Source:	Prestolite Electric Ltd - Greenford, London, UK
Date:	March 8, 2012
Bulletin No:	TSB4045
Models:	ADL Starter motors
Subject:	35262410 Starter motor replacement

Bulletin No: TSB4045

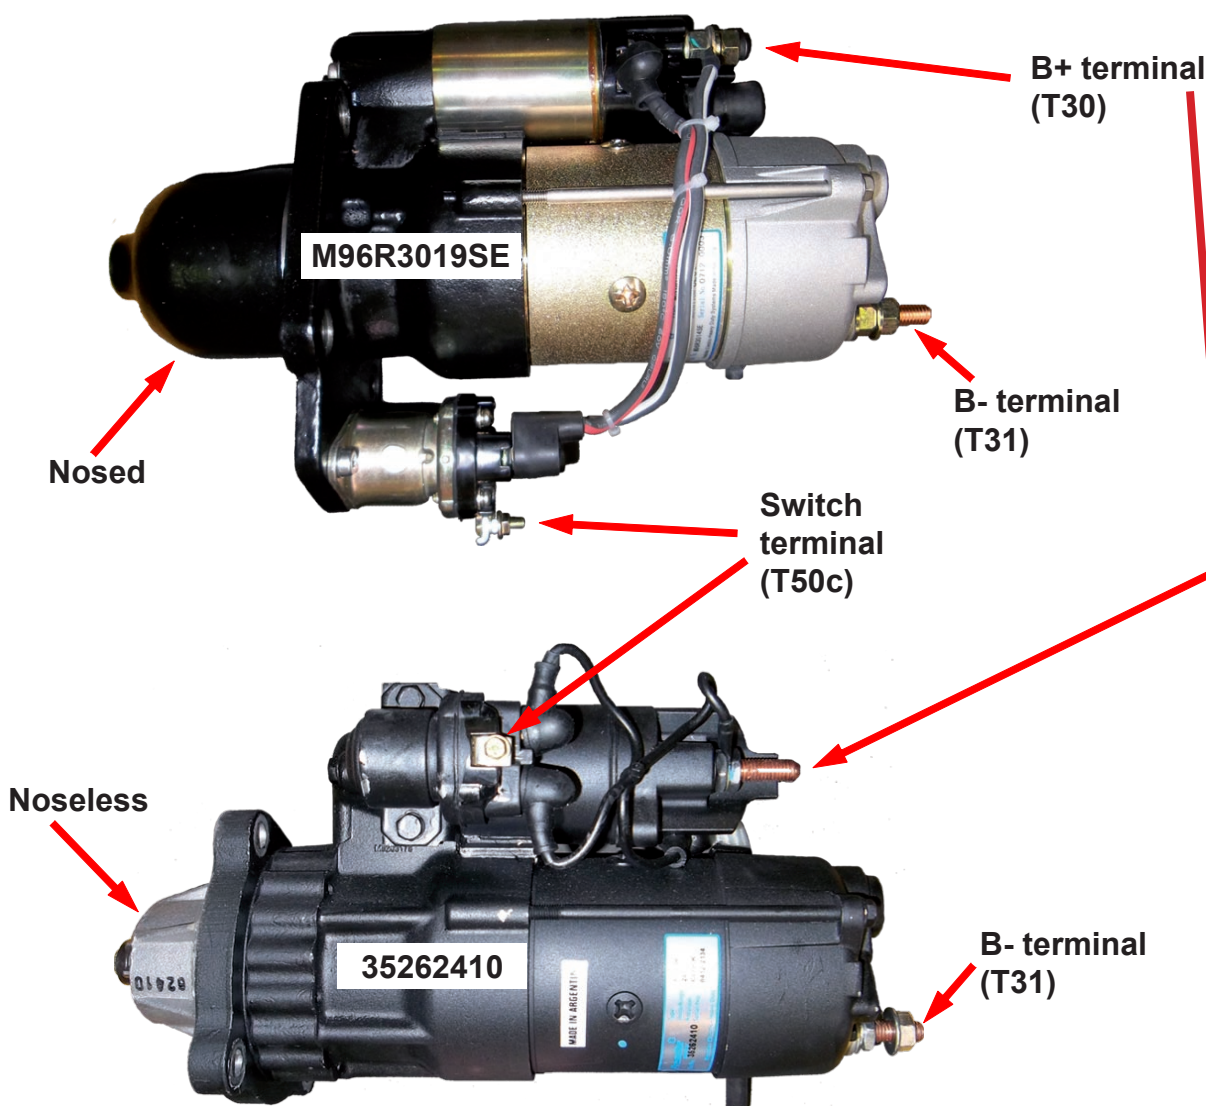
Please note location B+ (T30) M10 stud, B- (T31) M10 stud and Switch terminal (T50c) M5 stud, and note variances between 35262410 and M96R3019SE.

The new M96R3014SE offers:

- Easier access to the B+ and Switch terminals.
- Increased power.
- Removal and fitting through same space.
- Easier access to the top mounting bolt.

**Fitting instructions**

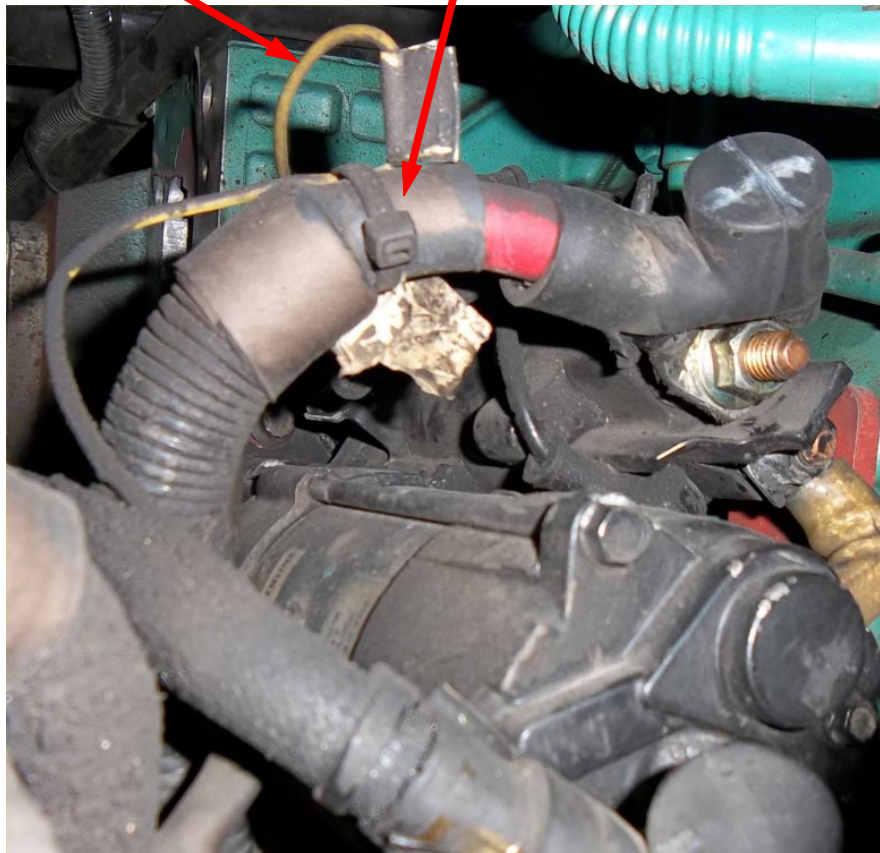
1. Cut cable tie on vehicle wiring harness as shown below.

Re-route the small lead (switch connection)

The Switch lead must be re-routed from top to the bottom of the starter, as the new M96R3019SE Switch connection is at the bottom of the starter motor.  
Remove and re-fit a secondary cable tie further along the wiring harness, if required.

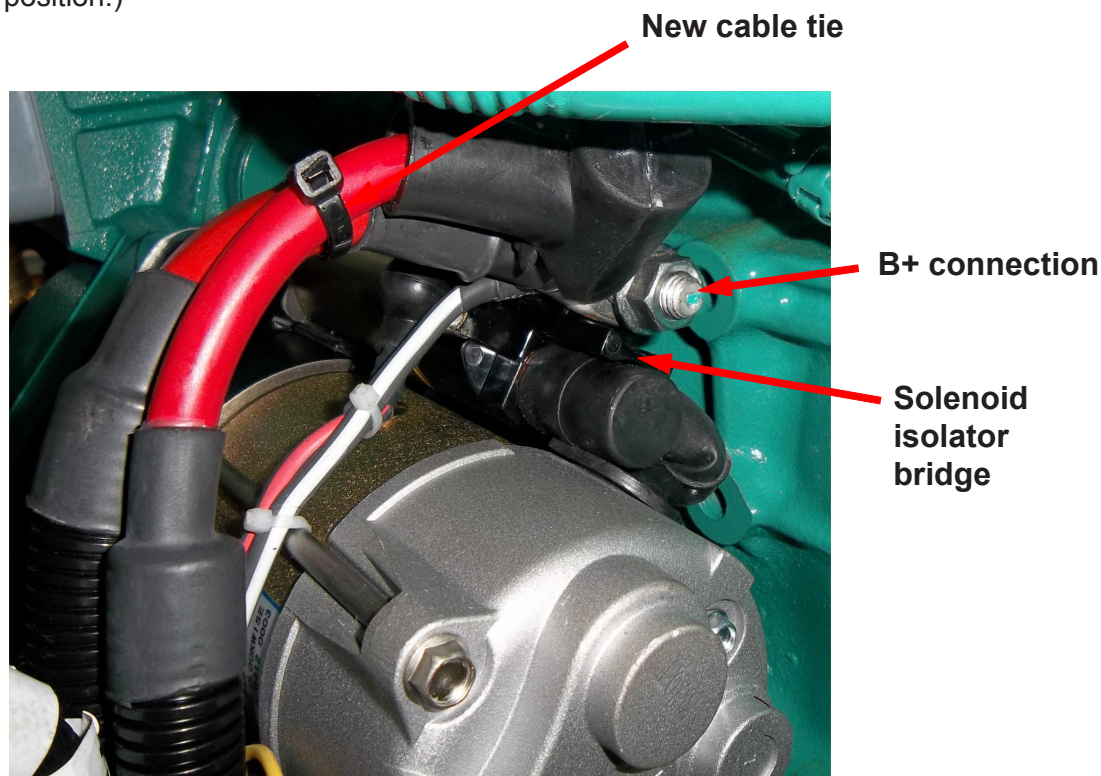
2. Fit new cable tie as shown below.

Fit battery positive cable to B+ terminal, as shown.

Before tightening the B+ terminal nut, ensure that the cables are not “resting” against the solenoid isolator bridge. (Also do not use the solenoid isolator bridge as leverage to manoeuvre the cable ends into position.)

3. Tighten the nut to 13.5 - 15.8 N.m

Check to ensure a gap between cable terminals and solenoid isolator bridge.

**Check for  
small gap**

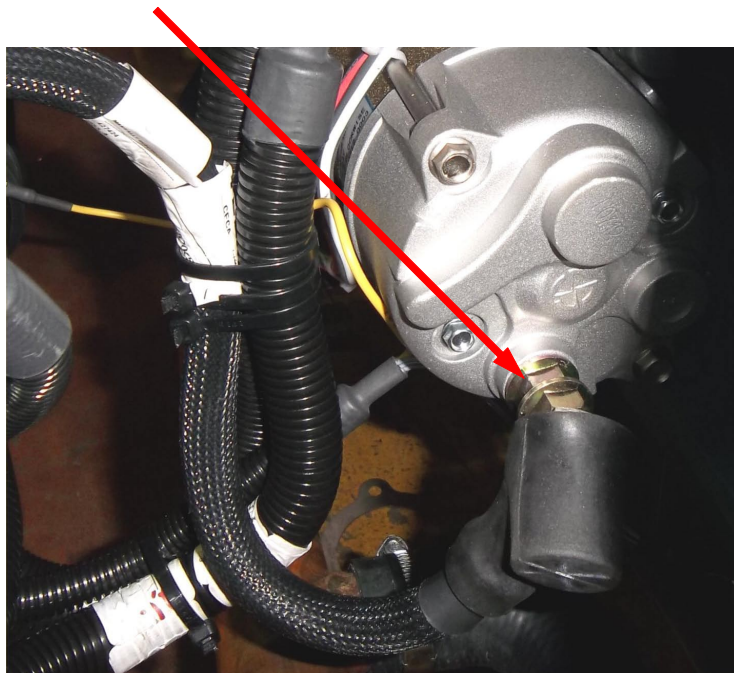
4. Fit B- (Earth) cable. Tighten to 13.5 - 15.8 N.m

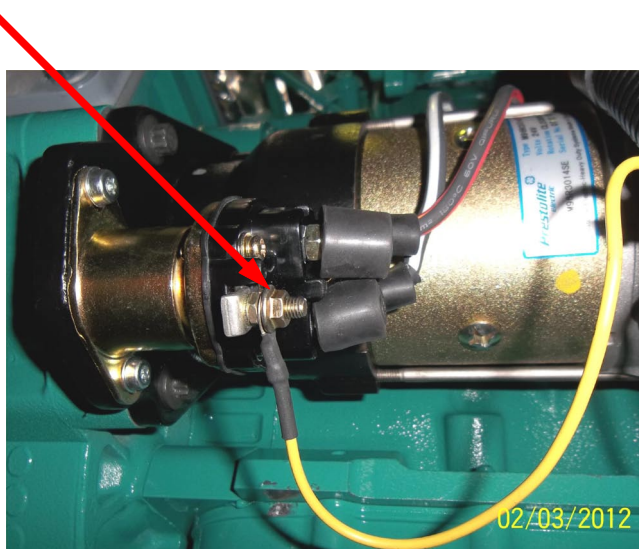
5. Fit Switch terminal (T30c). Tighten to 2 - 2.5 N.m
